**INDIAN HEALTH SERVICE HOSPITAL  
PINE RIDGE, SOUTH DAKOTA**

**POST OCCUPANCY EVALUATION**

**February 1997**

**ENVIRONMENTAL HEALTH AND ENGINEERING  
INDIAN HEALTH SERVICE**

(CS-1) Emergency Entrance-Proposed Heliopad

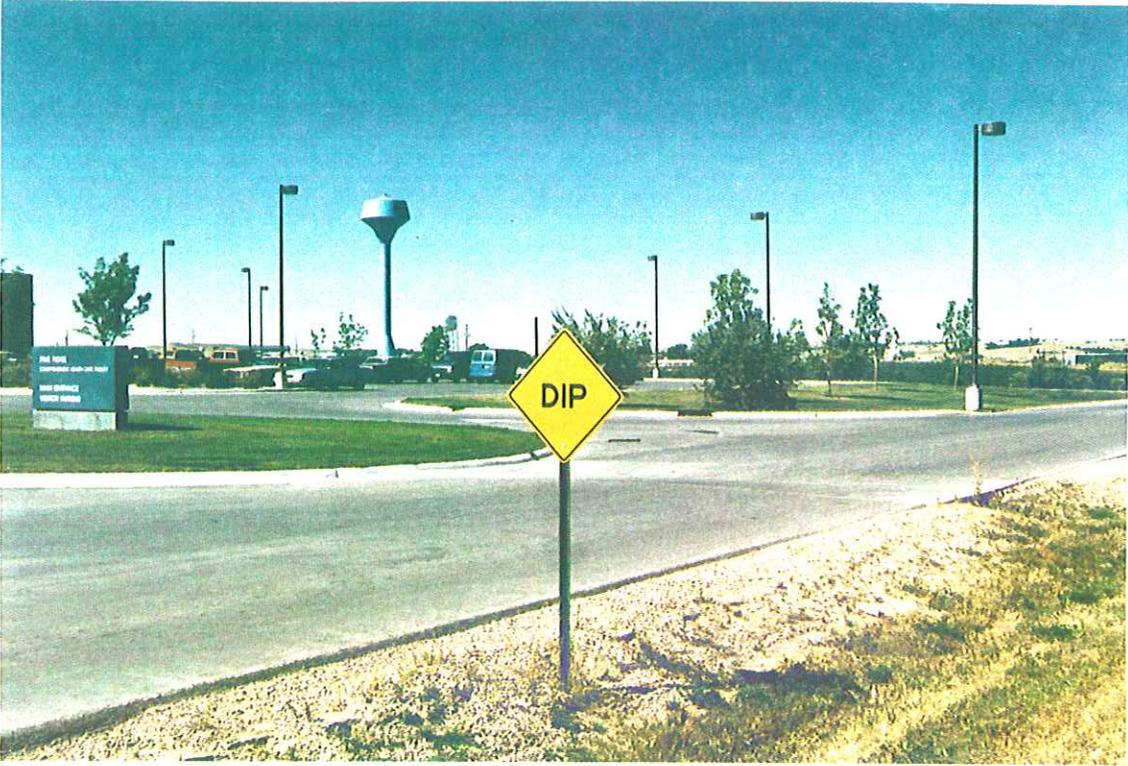
- d. **Helicopter Access:** A helicopter landing area in front of the emergency entrance was designated on the drawings, but not built. (See *CIVIL/STRUCTURAL* comment A.2 for additional discussion.)

(M-1) Separate Surgery Chiller

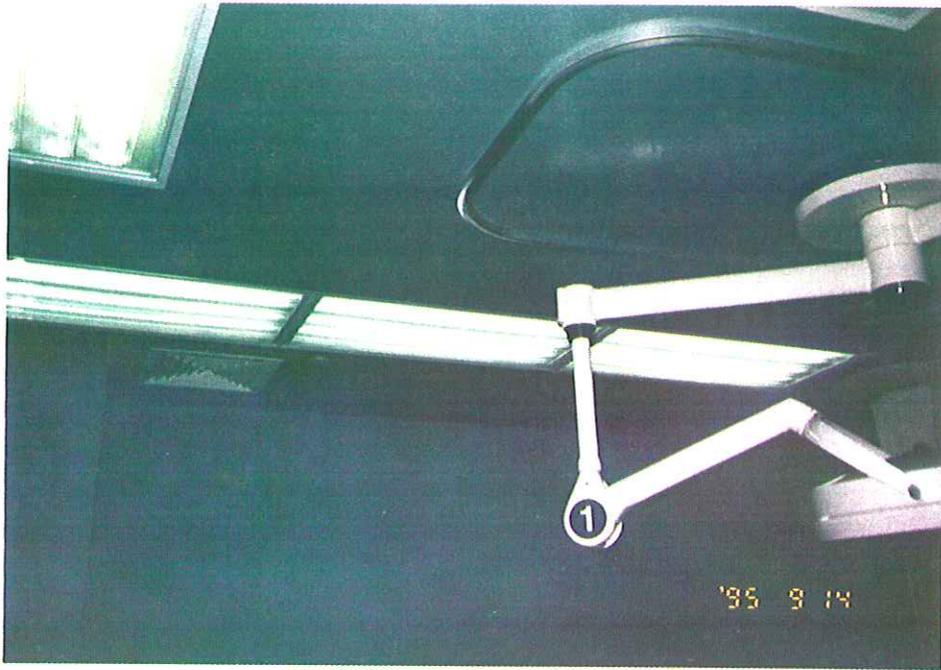
- (2) **Separate Surgery Chiller** (see photo M-1): The operating rooms and computer rooms are on separate air handling units which receive their chilled water from a separate chiller. Since these spaces are required to be kept at a colder space temperature than the other areas of a hospital, colder supply chilled water is usually required. Providing a separate chiller means that the main chilled water plant does not have to provide colder water than necessary just to serve these departments. The main chilled water supply temperature can be reset higher to satisfy the cooling demands of the majority of the hospital which operates at warmer space temperatures (72°F to 78°F as opposed to 65°F to 68°F space temperature required in surgery).

Overall, the central plant appears well laid out with adequate space for operation and maintenance (See Photo M-2). The design provides good flexibility as well as reliability. The provision for a separate surgery chiller is a good example.
